LOCAL HISTORIC DISTRICT: Plaza Midwood

PROPERTY ADDRESS: 1416 Pecan Avenue

SUMMARY OF REQUEST: Addition

Charlotte Historic District Commission Case 2017-481
HISTORIC DISTRICT: PLAZA MIDWOOD
ADDITION

1 PROPOSED SITE PLAN
1/16" = 1'-0"

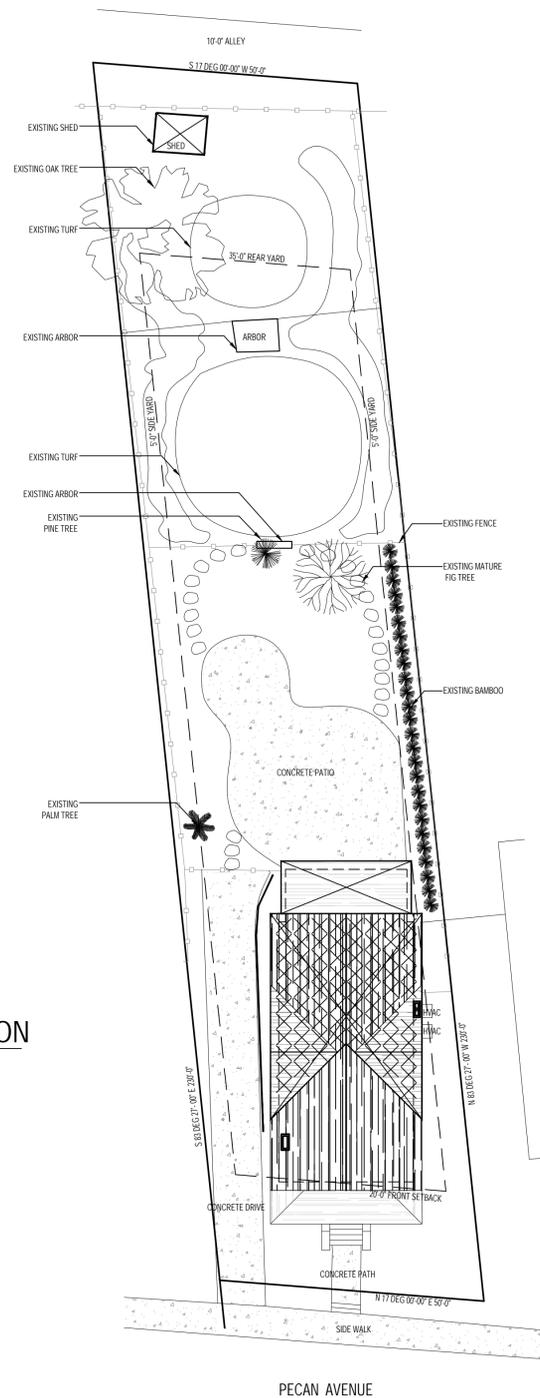
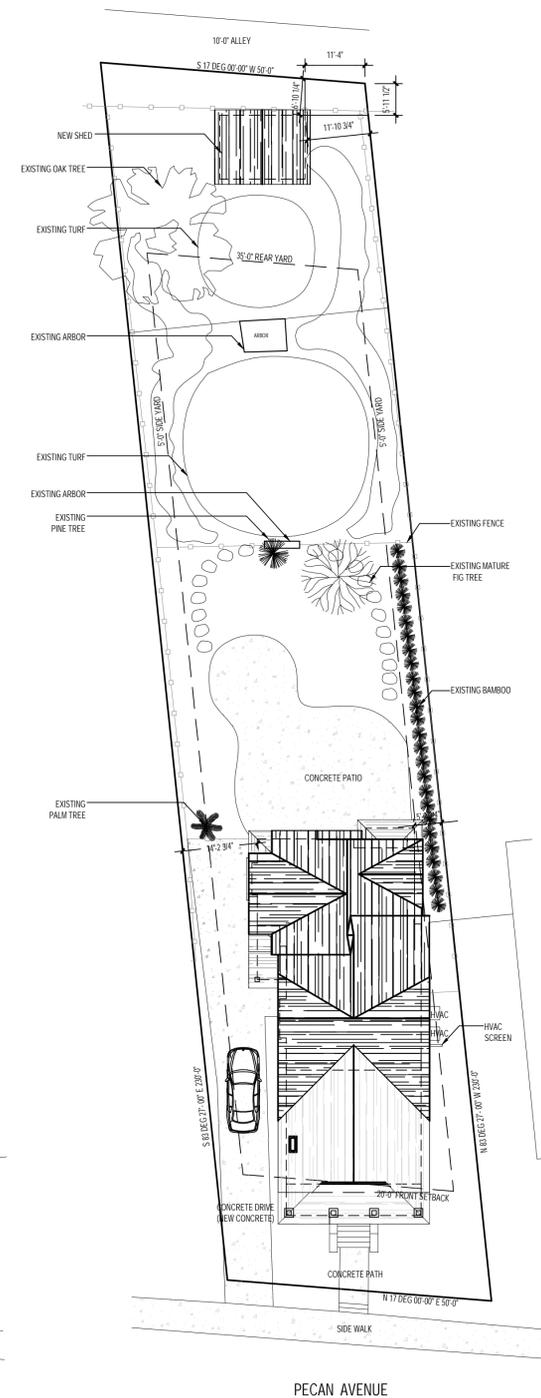
The application was continued from September for the following: 1) Simplify the massing of the left side elevation addition, 2) Simplify the rear connection on the left side so it is more a part of the yard.

2 PROPOSED LEFT ELEVATION SHOWING EXISTING PROFILE
1/4" = 1'-0"

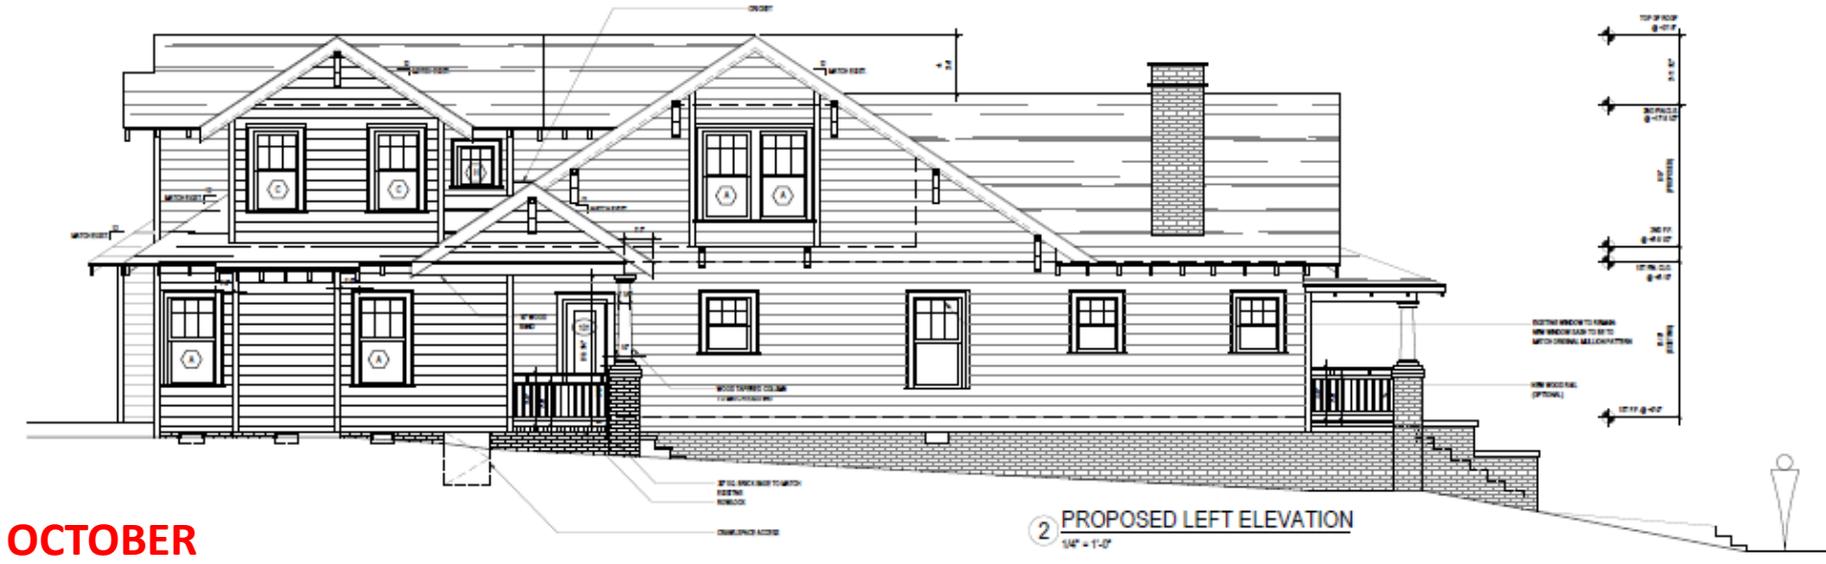
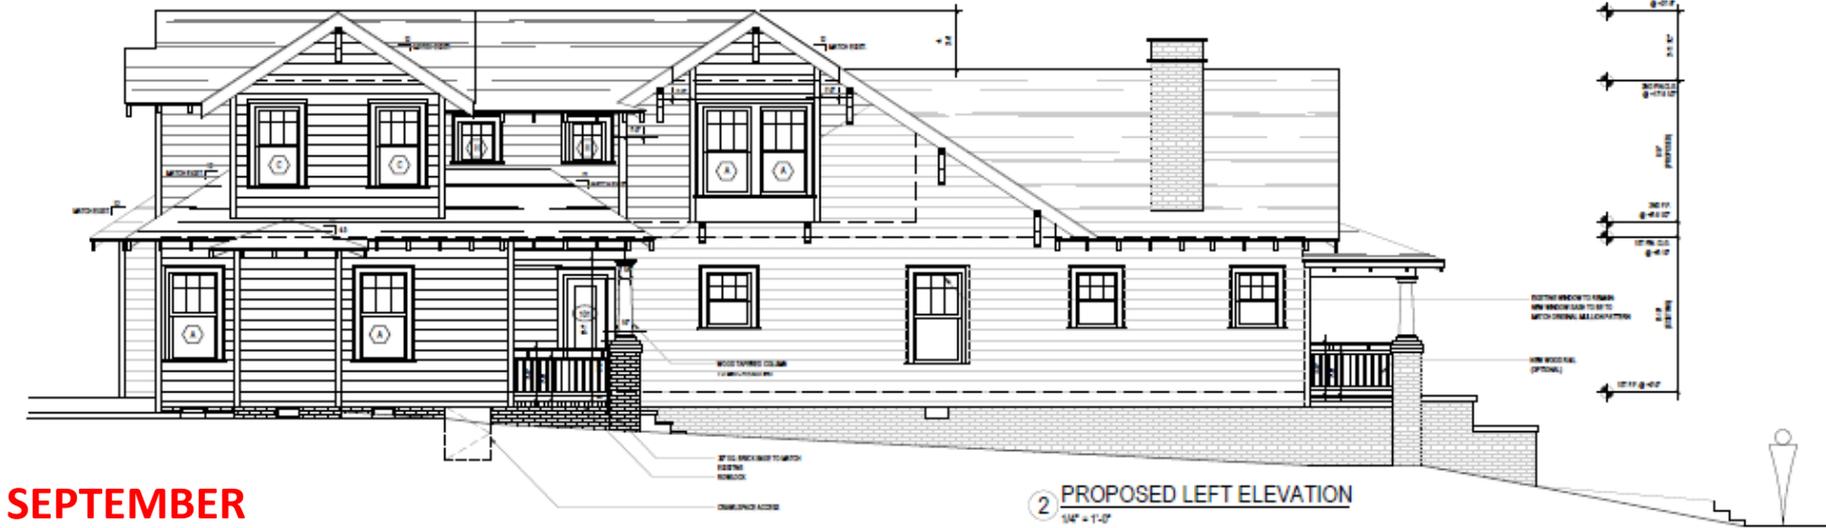
- **SIMPLIFY THE MASSING OF THE
LEFT SIDE ELEVATION ADDITION**
- **SIMPLIFY THE REAR
CONNECTION ON THE LEFT SIDE
SO IT IS MORE A PART OF THE
YARD**
